COAL ASH IMPOUNDMENT SITE ASSESSMENT REPORT

**Newton Power Station
Ameren Energy Generating Company
Newton, Illinois**

KLEINFELDER PROJECT NUMBER 112618-4

April 2011

Photo 19 – Primary pond outlet

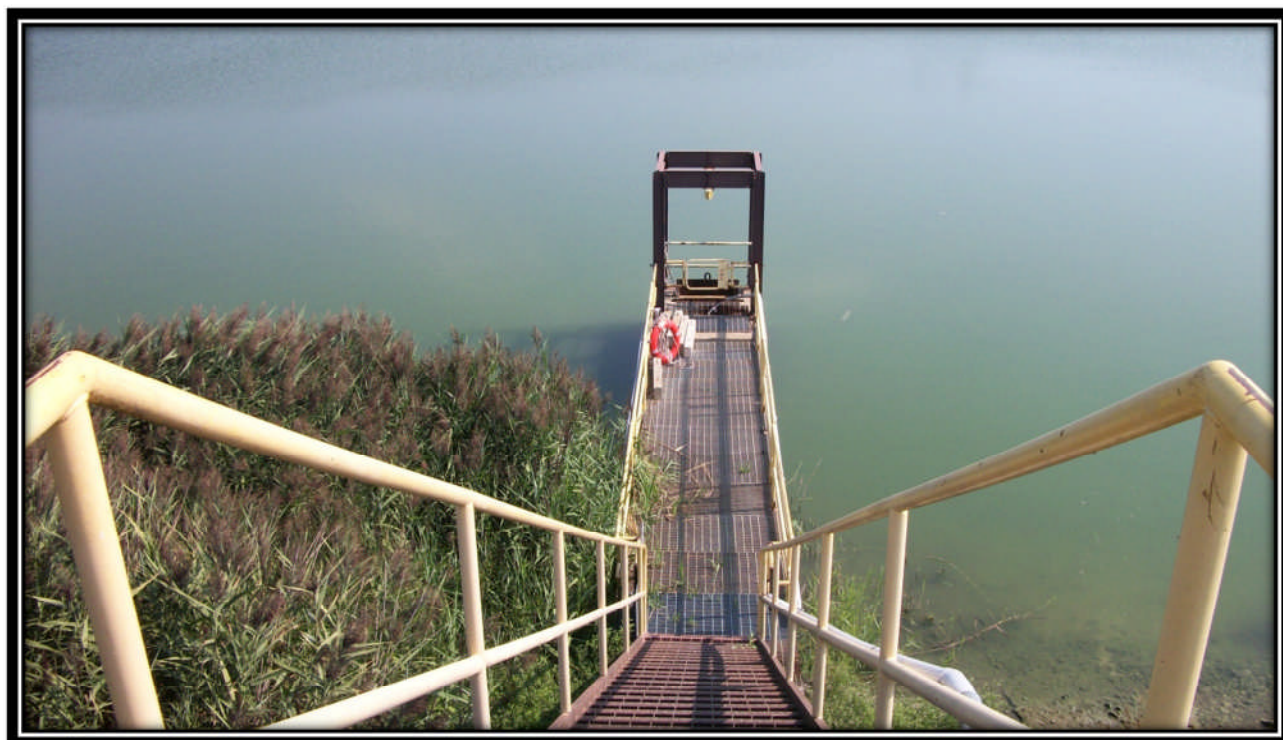
The outlet structure in the Primary Ash Pond area is a two level catwalk with stairs connecting them. Each level is a single span pedestrian walkway with a steel W-section girder superstructure. Each catwalk has a handrail and connects the embankment at one end of each walkway to a reinforced concrete weir box. The upper catwalk is approximately 25 feet long, and the lower catwalk is approximately 35 feet long with the drop height in the weir boxes ranging from approximately 19 to 24 feet in height. The weir boxes have lateral steel bracing supports at approximately 8 feet on center. Due to the height of the weir boxes, this provides additional support during high wind or seismic events. The weir boxes have stop logs to control flow in and out of the reinforced concrete box. The concrete appeared to be in satisfactory condition on both the upper and lower weir boxes. The catwalk bridge access portion appeared to be in satisfactory condition, and the superstructure appeared to be intact with minor corrosion. The catwalk substructure concrete foundations appeared to be in satisfactory condition, as well, with little to no concrete spalling or scaling. The steel girders, handrail, and stairs appeared to be in satisfactory condition. Refer to Photographs 19 and 20 in Appendix B for further clarification.

The outlet works of the Primary Ash Pond are shown in Photographs 19 and 20 and consist of a weir box leading to a 30-inch slip-lined CMP. The outlet structure is accessible via metal stairs and a catwalk. Water from the outlet is discharged into the Secondary Ash Pond.

- Overall, the outlet works system appeared to be functioning as intended at the time of inspection.
